From: Griffin, Tim (Contractor)
Sent: 27 March 2026 16:01
To: Altman, Rebecca
Cc: Oliveira, Marta (Contractor); Dyer, Tim; Ellison, Mark
Subject: RM/25/100614 Land West of Burnetts Lane, Horton Heath, Eastleigh, SO30 2HH - The Folds

My further minor comments on the landscape general arrangement plan Dwg. No. STA-17-ZZ-DR-L-2004 Rev A follow below:

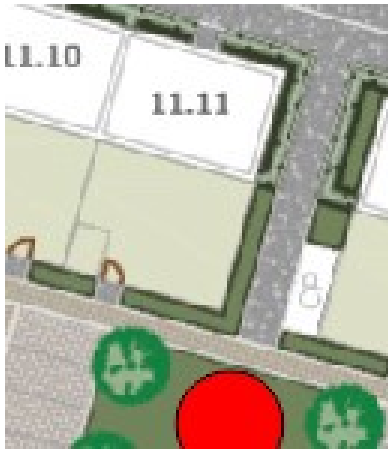
d/ Whilst I support the retention of existing hedges, is there a risk that this balancing basin area is 'hidden' in wider views which may encourage anti-social behaviour? How high is the existing hedge along the W edge and would it obstruct all views from the west ?

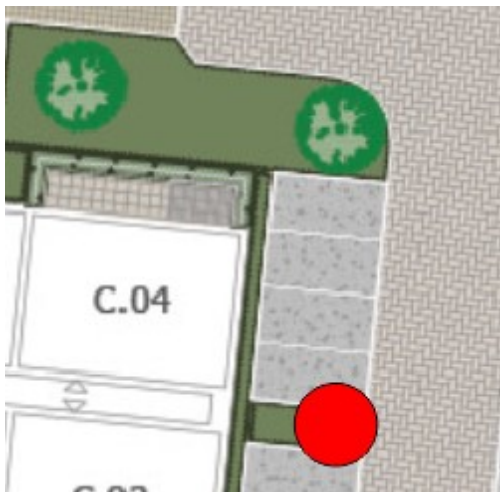
h/ Light column moved to opposite side of road creating space for additional tree?

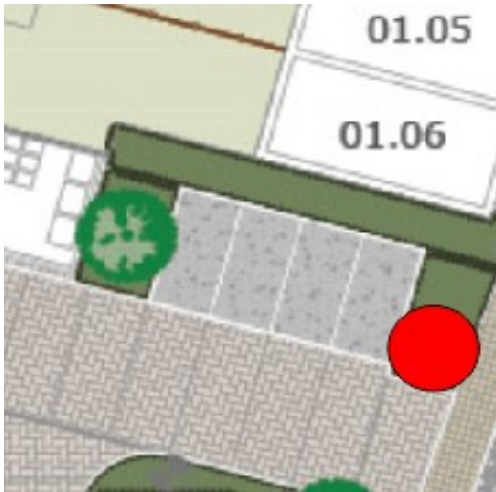
j/ Additional tree?
